**Condensation Dryer NEXUS 4 series**

**599 521 868 EN**

**New float microswitch and float body.**

**old - 125851315/7**  
**old - 125851313/2**  
**new - 125851316/5**

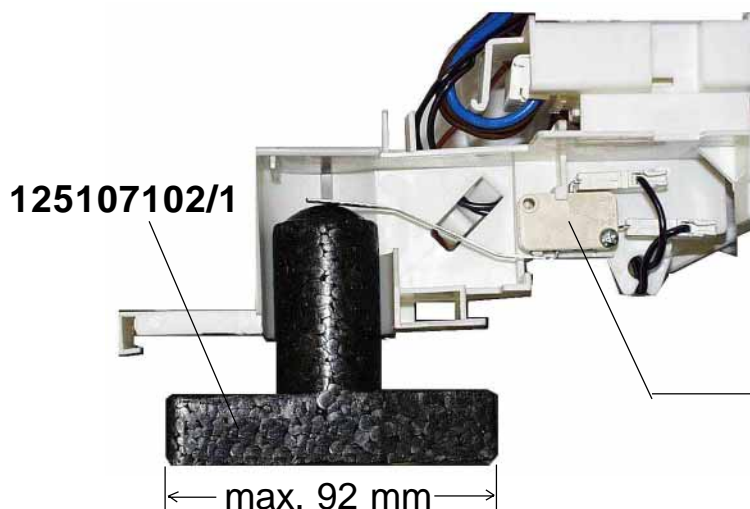
The display provides the information that the condensate receptacle is full; there is however no or too little condensate in the condensate receptacle.

One possible cause for the error was determined to be the „float type switch“, spare part No. **125 851 315/7** or **125851313/2** respectively, they having a gold contact layer which has not always been homogenously applied to the internal switch contact layer. This can result in partial contact uncertainties/interruptions.

The microswitch is an opener contact. When the condensate rises, the float floats upwards, activates the switch and the pump is activated. The falling water level reactivates the switch. Due to the aforementioned contact uncertainty, it is possible that the contact can be temporarily interrupted although a mechanical switch-over has internally taken place. Via the time-related inquiry routine, the „interrupted“ contact in the electronics system is interpreted as >receptacle full< and this is then displayed accordingly.

**Besides the microswitch, you should also replace the float body or at least check the long dimension of the lift cuboid (< 92 mm).**

**In case of doubt, the old microswitch must be replaced.**

**Manual cutting off to 92 mm is also possible.**

The previous microswitches for the customer service have already been replaced by a new improved type with the spare parts No. 125 851 316/5 and the spare parts inventory has already been adjusted.
